CRASH PLATE WELDING INFORMATION

ISSUE

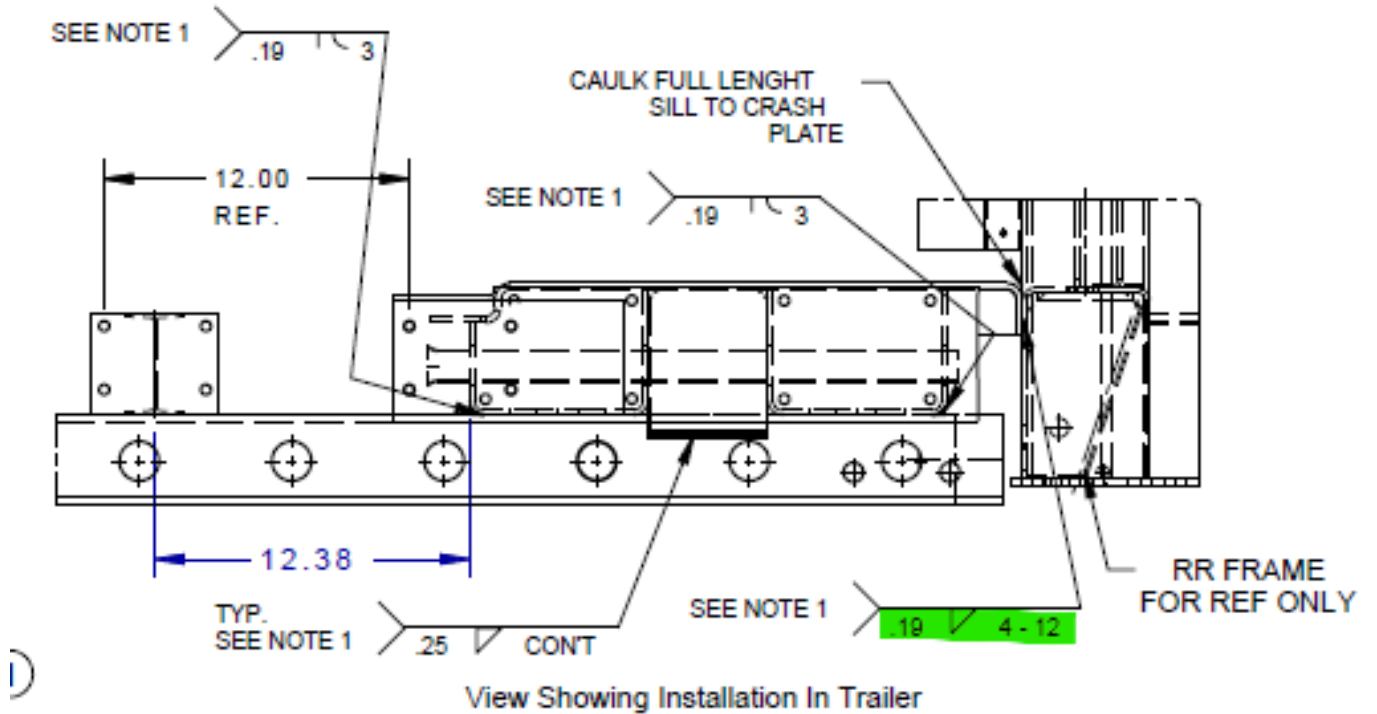
The issue that has occurred is the rear of the crash plate was not welded to the rear frame. The circled seam should have welds present.

The welds called out are highlighted on the attached drawing. There should be a 4" long 0.19" sized weld spaced every 12".

FIX (CONT.)

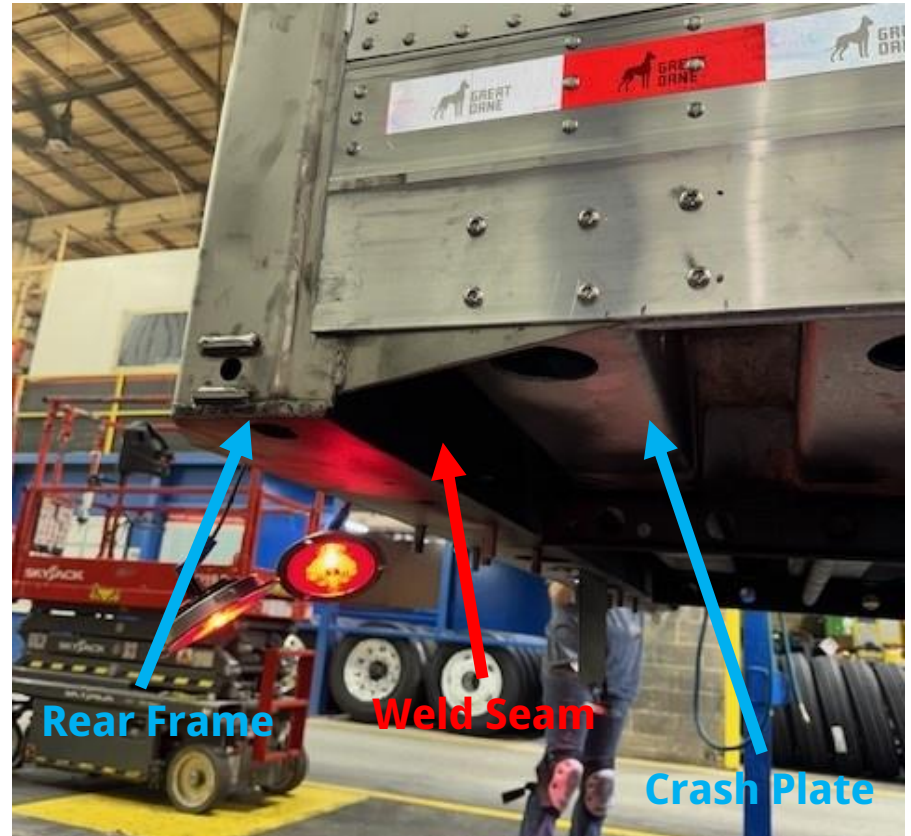
When looking on the underside of the trailer, the seam is located between the front side of the rear frame and the rear of the crash plate

Each weld should be 4" long and
0.19" in size

The welds should be spaced every 12".

Once finished welding, coat welds with undercoat to prevent rusting.
